CK-2209
CK-2209A

MOWHOKAM EAST 0.1km

2020 Inspection

CBR iPad Offline Ver 0.33

Downstream left bank missing appropriate length ties

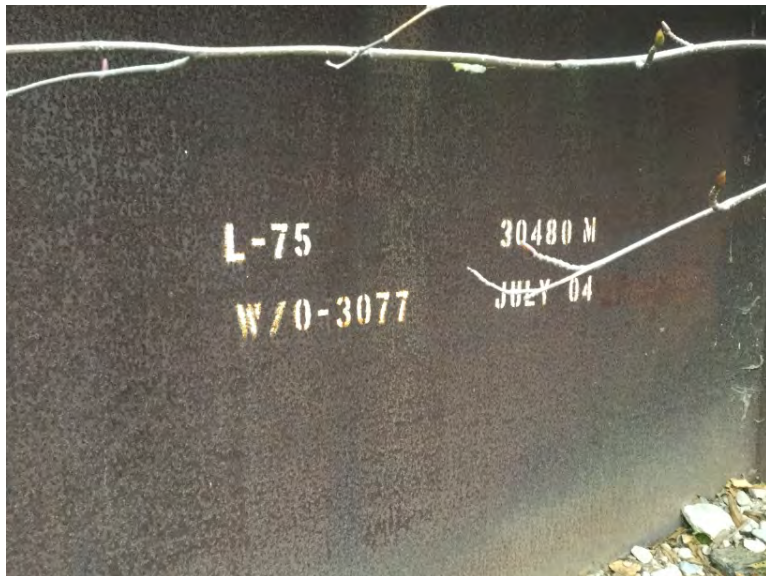
The subdeck and planks were recently replaced; however the cross ties were not. The cross ties were cored and sampled at various locations near their ends and rot was found, some ties had up to 50% rot at the sampled location. Also, the existing cross ties are not long enough in locations along the downstream ends to fully support the timber guardrail. The cross ties require replacement prior to industrial activity, when they are replaced ensure they're fastened to the girders. Add log fenders to each corner of the bridge. Limit loading to L30 or 27 tonnes. Post load rating signs. Continue to monitor the riprap condition and consider replacing it with angular material, that is well graded, sufficiently thick, keyed together and into the stream banks. Please submit the record drawings, structural drawings and Crossing Assurance Statements for this original installation.

Repair Item	Repair Description
1	Post load rating signs
2	Replace cross ties prior to industrial activity, and ensure they are fastened to the girders
3	Install log fenders at all 4 corners
4	Add angular riprap to each abutment, ensuring its well graded, sufficiently thick, and keyed together and into the stream banks
5	
6	
7
